Technical Note

To: Whom it May Concern
From: Richard Manock
Subject: Home Farm, Llay – Crown Crossroads Improvements
Ref: 065665-CUR-00-XX-RP-D-72001-V00
Date: 26 June 2019

- 1.1 This technical note has been prepared to provide a narrative to support approval of the suggested improvements to the Crown Crossroads signalised junction indicated on drawing '065665-CUR-ZZ-XX-DR-D-9562-C02 Crown Crossroads MOVA Signal Design' (*Annex A*).

Annex A

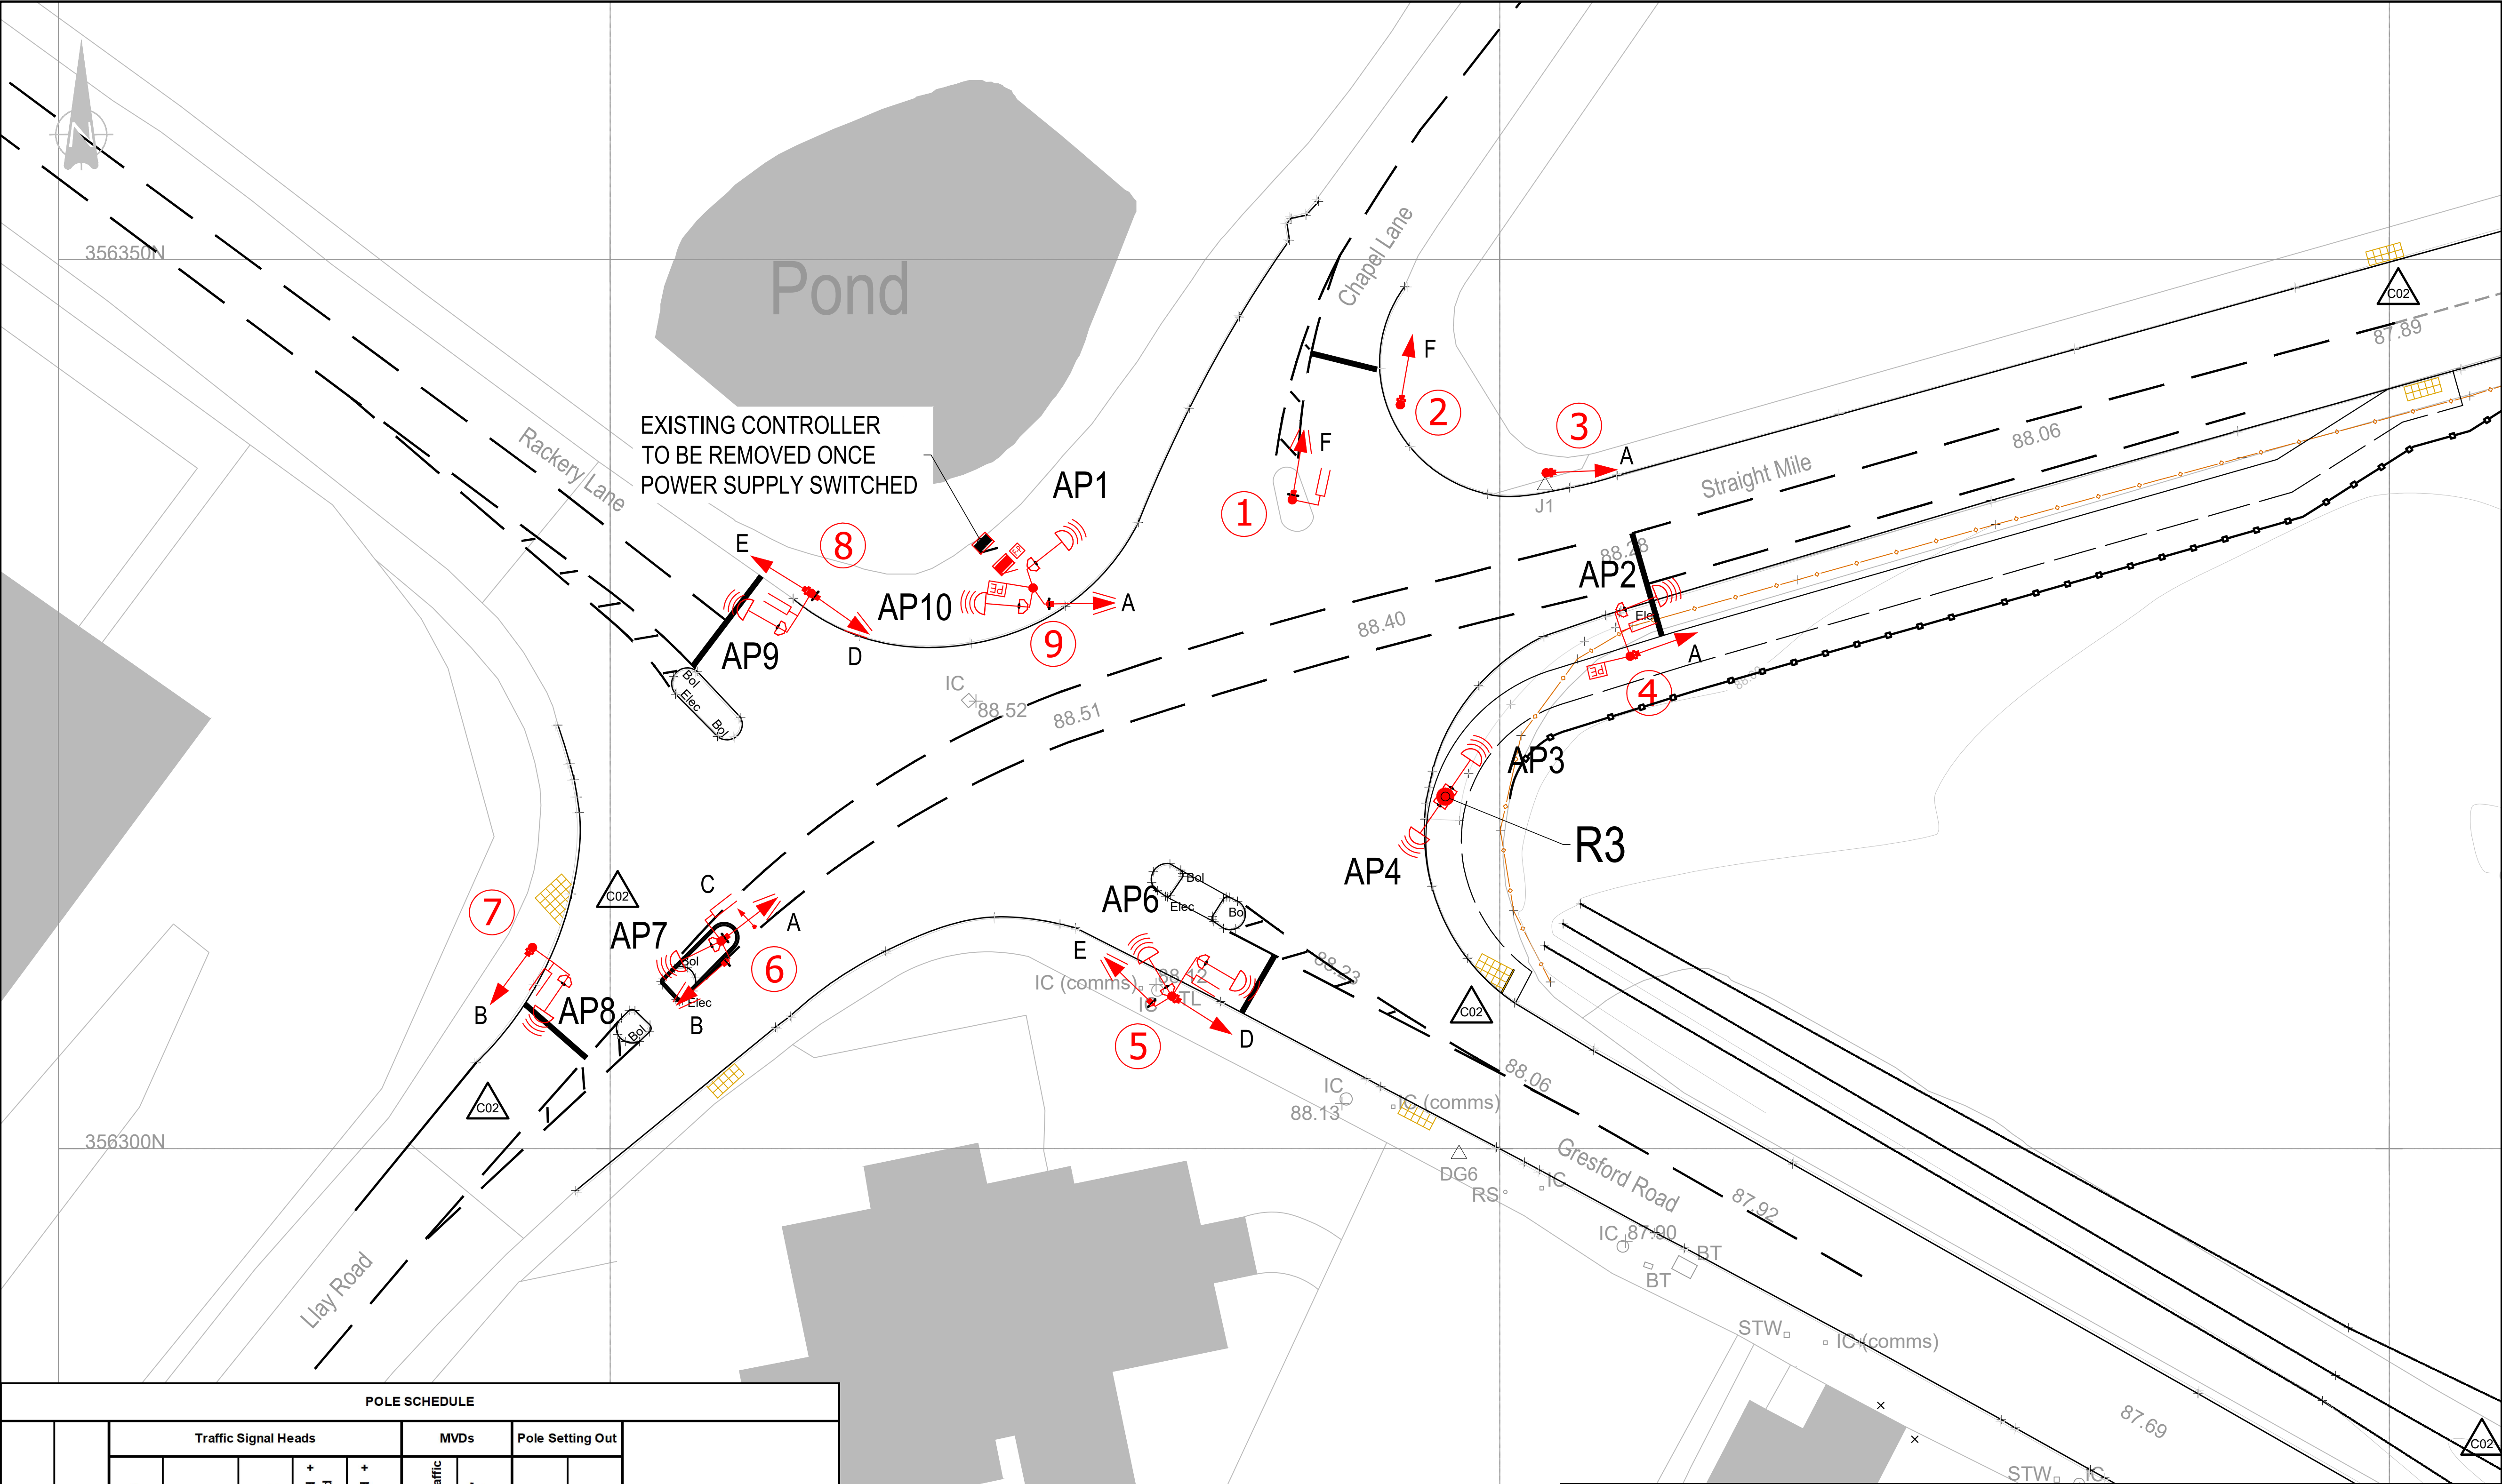
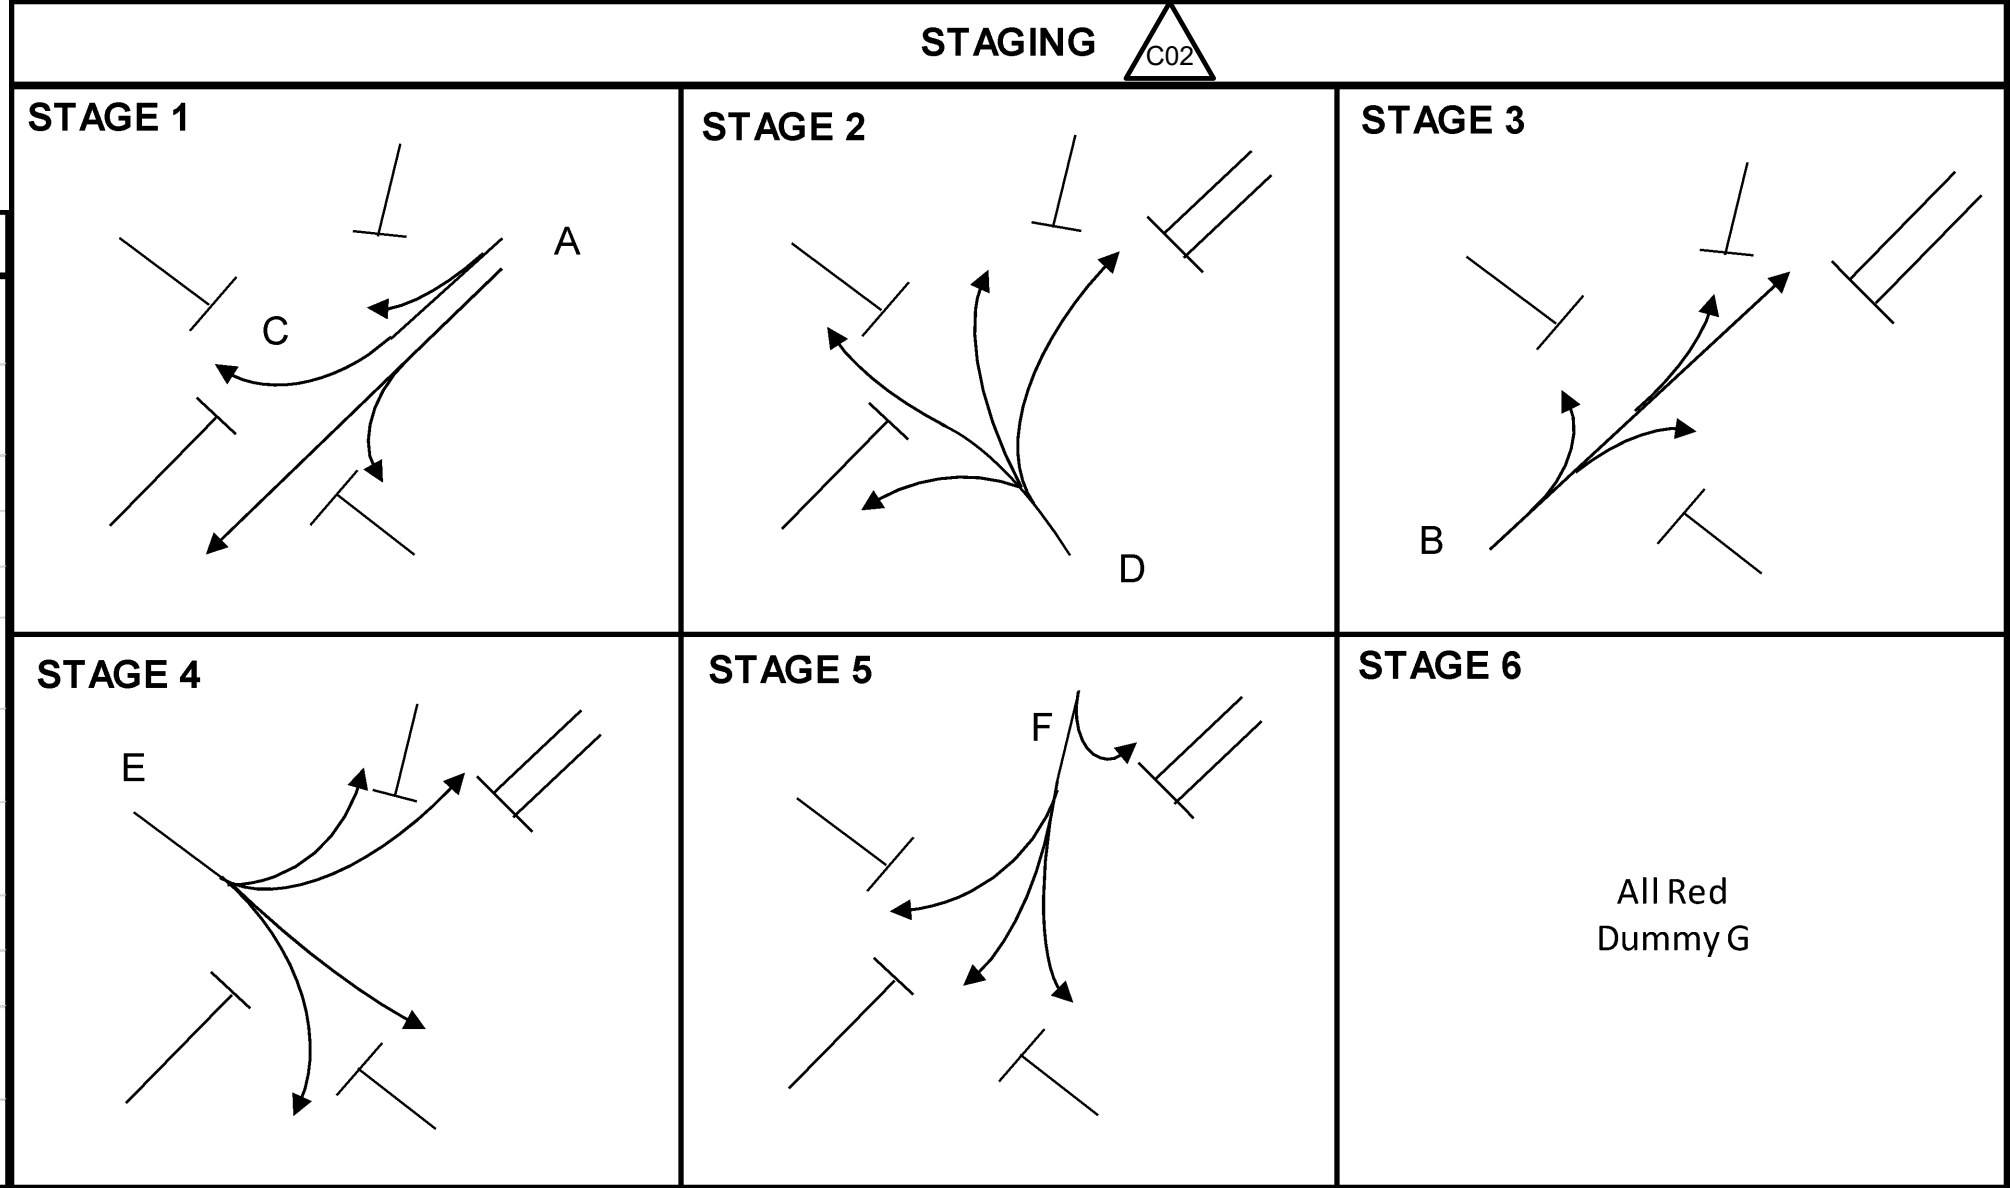
- 1.7 However, the findings of the Road Safety Audit & Designer Response (*Annex F*), undertaken as part of the S278 approval process, raised concerns over the safety of the opposing right turn movements for Straight Mile and Llay Road and the lack of provision for safe pedestrian movement.

- 1.8 The considered recommendations of the Road Safety Audit led to the amendments to the planning layout as shown in *Annex A*, namely:
 - Each arm of the junction having its own stage (Chapel Lane in every two cycles).

- Increased provision for safe pedestrian movement around the junction.
- 1.9 The latter has considered movement across Llay Road, Straight Mile and Gresford Road as the three critical arms in terms of pedestrian routes.

- Opposing right turn and straight on movements of Straight Mile and Llay Road are removed allowing free flow of right turns through the junction that will in turn prevent blocking of the junction i.e. it is understood that currently right turn movements from Straight Mile into Rackery Lane continue after the Rackery Lane arm has entered its own green stage.

- Implementation of MOVA controls will improve junction operation outside the peak periods by prioritising arms with greatest demand.
 - Individual vehicular stages on each arm increase gaps for pedestrians to navigate the junction.

- Uncontrolled pedestrian crossing provision has been incorporated across the Llay Road, Straight Mile and Gresford Road arms.
- 1.12 The inclusion of an on-demand pedestrian stage in the proposals has been discounted as:

- There are no footways on either Chapel Lane or the east side of Rackery Lane to warrant crossing points across these arms.
- 1.13 Therefore, the recommended conclusion of this process to best meet the intent of the planning approval is for the implementation of the current proposal; namely that shown on drawing ‘065665-CUR-ZZ-XX-DR-D-9562-C02 Crown Crossroads MOVA Signal Design’ (*Annex A*).
